# Certificate of Appropriateness

<b>Property</b>	2205 N. LAKE DR.	North Point South HD
<b>Description of work</b>	Restore window openings on west façade to original size. Install new wood, non-clad windows with matching new wood storm windows and repair brickwork per conditions and drawings below.	
<b>Date issued</b>	11/2/2022	PTS ID 115324 COA: WINDOW ALTERATIONS

Proposed Revisions to West Facing windows.

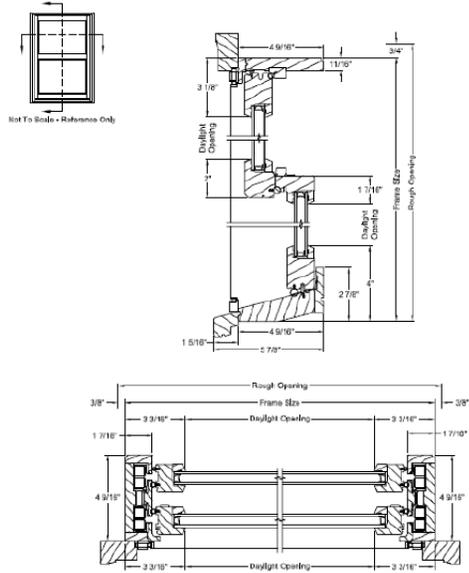
Sills of (3) west windows will be lowered to match sills of adjacent windows on south elevation. Head of windows will remain as is. Existing stone sills will be cleaned and reused in lowered position. See included documentation of window and storm products.

For reference only:  
Head of (3) south windows will be raised to match head of adjacent windows on west elevation. Existing stone window sill to remain as is. This work was previously approved by Historic Preservation Commission, see COA PTS ID 114621

Ultimate Wood Double Hung

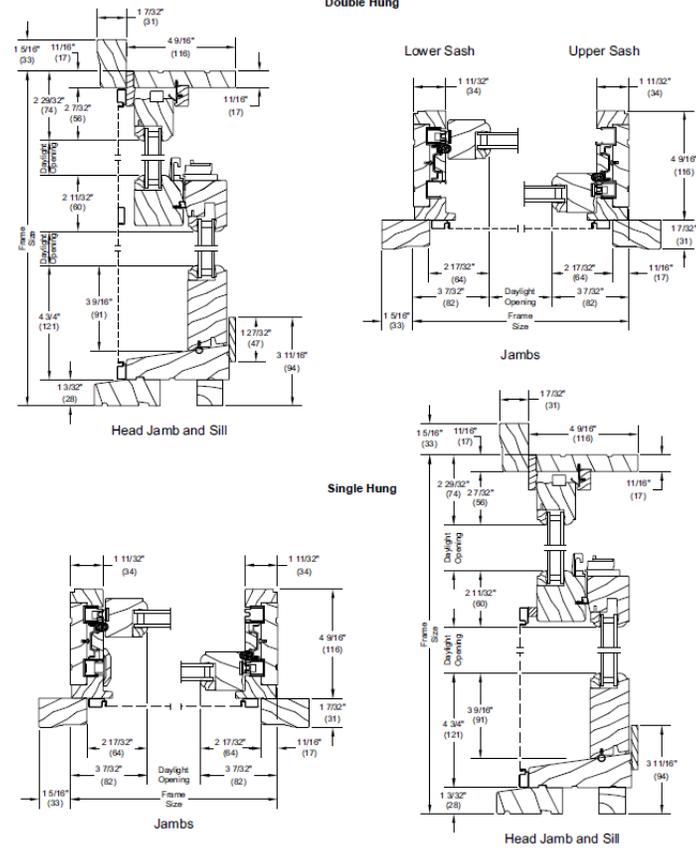
Windows will be replaced with all wood windows - inside and out, with wood storm windows that have a wood frame with sash heights that match primary windows. Window product will be Jeld-Wen Siteline wood or similar (Marvin Ultimate Double Hung WoodLine)

Storm window will be Marvin Alpine Wood or similar
